HPC #34/08-03A Julius Marlow House
Master Plan Site 34/08

MEMORANDUM

SUBJECT: Historic Area Work Permit

HISTORIC PRESERVATION COMMISSION STAFF REPORT

Proposed West Elevation

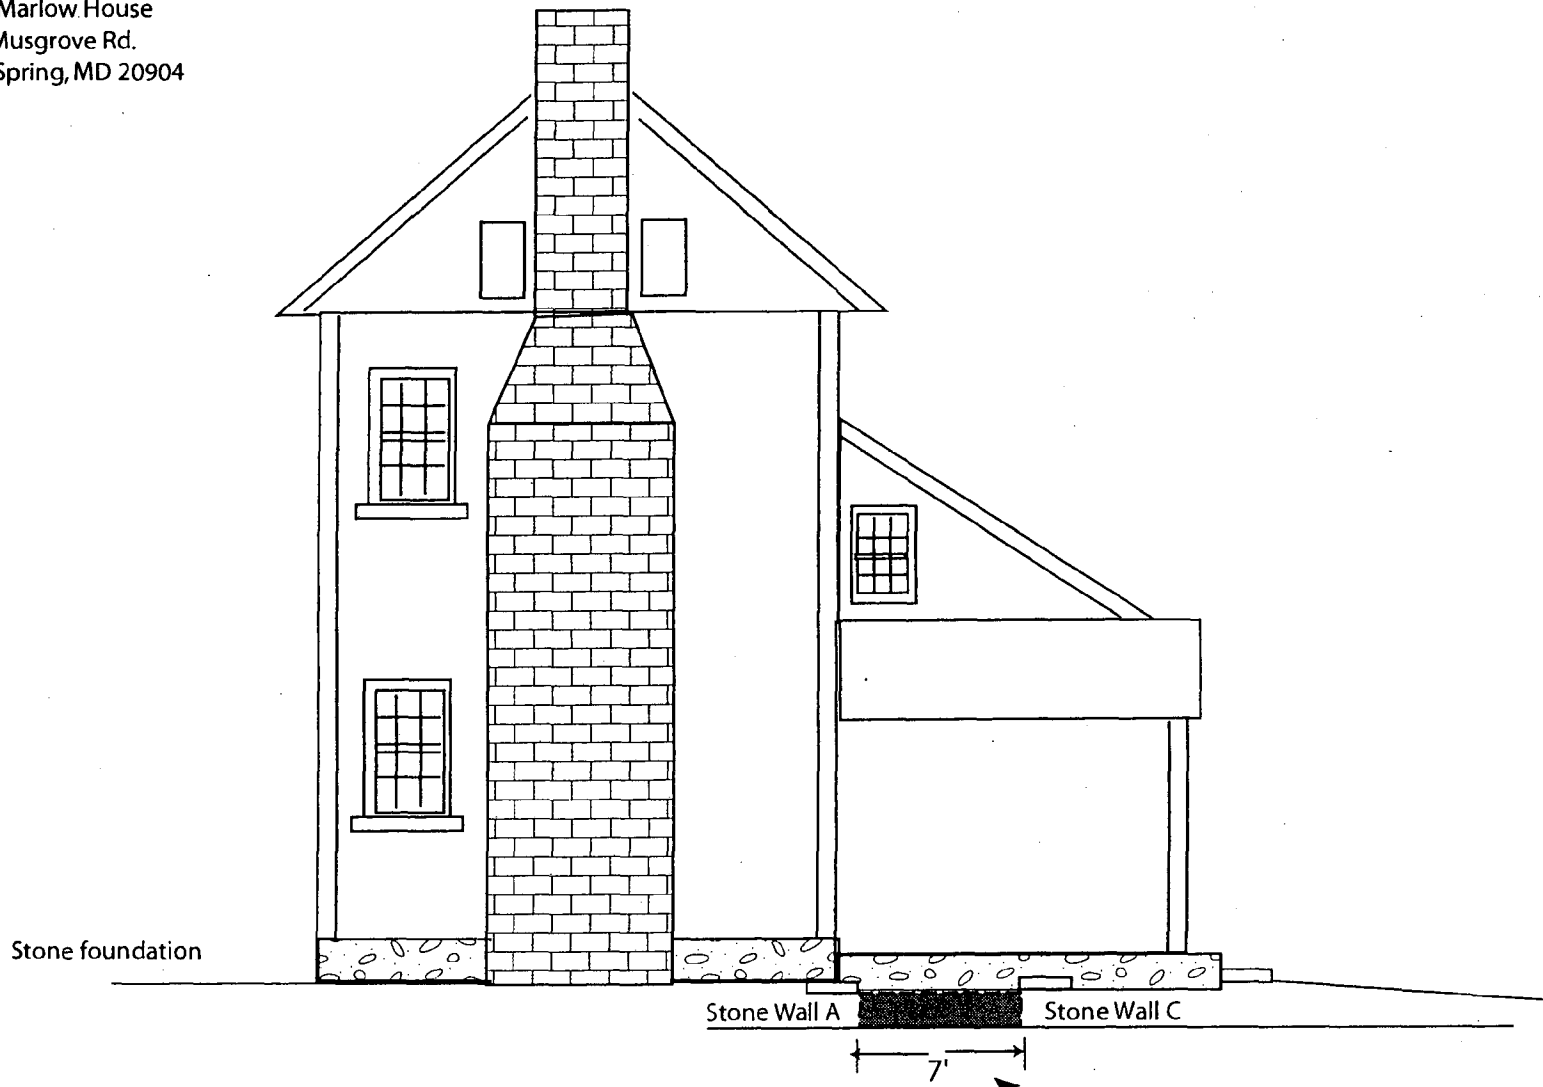
- Install an extensive drainage system with an underground piping system to take water away from the house
- Re-build three stone walls outside of the basement using the existing stones where possible and matching existing mortar; new walls will have weep holes
- Repair if possible or replace in-kind three non-original doors
- Excavate behind Wall B (see Circle 15) to create a shelter for mower and tools

Stone wall B will
have an opening for storage

Staff agrees with the applicant that the new drainage system will ultimately benefit the house and add to its longevity by keeping it dry. The three reconstructed walls behind the house will be very similar to the existing walls but will be better constructed, and the underground area for tools will not adversely impact the resource. All the proposed work that would be above-ground and visible is not in the front of the house. Staff recommends approval.
